Lew W. Myers  
Senior Vice President412-393-5234  
Fax: 724-643-8069May 12, 2000  
L-00-008U. S. Nuclear Regulatory Commission  
Attention: Document Control Desk  
Washington, DC 20555-0001**Subject: Beaver Valley Power Station, Unit No. 1 and No. 2  
BV-1 Docket No. 50-334, License No. DPR-66  
BV-2 Docket No. 50-412, License No. NPF-73  
License Amendment Request Nos. 280 and 151**

Beaver Valley Power Station, Unit No. 1  
License Amendment Request No. 280  
UFSAR Update for Revised Radiation Dose Calculations

Beaver Valley Power Station, Unit No. 2  
License Amendment Request No. 151  
UFSAR Update for Revised Radiation Dose Calculations

### Beaver Valley Power Station, Unit Nos. 1 and 2 License Amendment Request Nos. 280 and 151 UFSAR Update for Revised Radiation Dose Calculations

FIGURE 14B-1  
LOSS-OF-COOLANT ACCIDENT RELEASE PATHWAYS  
BEAVER VALLEY POWER STATION UNIT NO. 1  
UPDATED FINAL SAFETY ANALYSIS REPORT

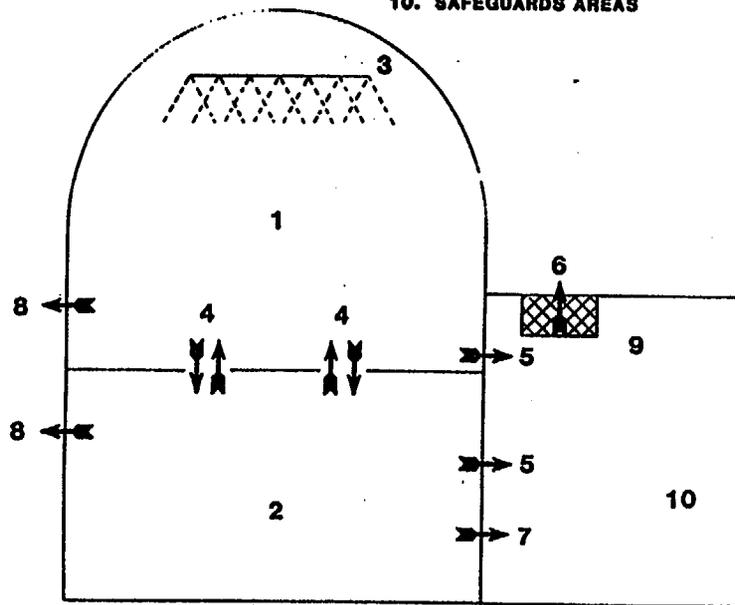
Affected UFSAR Figure: Revise Figure 14B-1

Figure 14B-1 illustrates, schematically, the leakage model. The containment free volume is assumed to consist of two regions: a sprayed region and an unsprayed region. The processes acting simultaneously on the activity in the unsprayed region are:

A single region model was used in the realistic case. This model used expressions similar to those in Section 14B.9.2, expanded to include removal by sprays for radioiodines. Figure 14B-1 illustrates the release pathways.
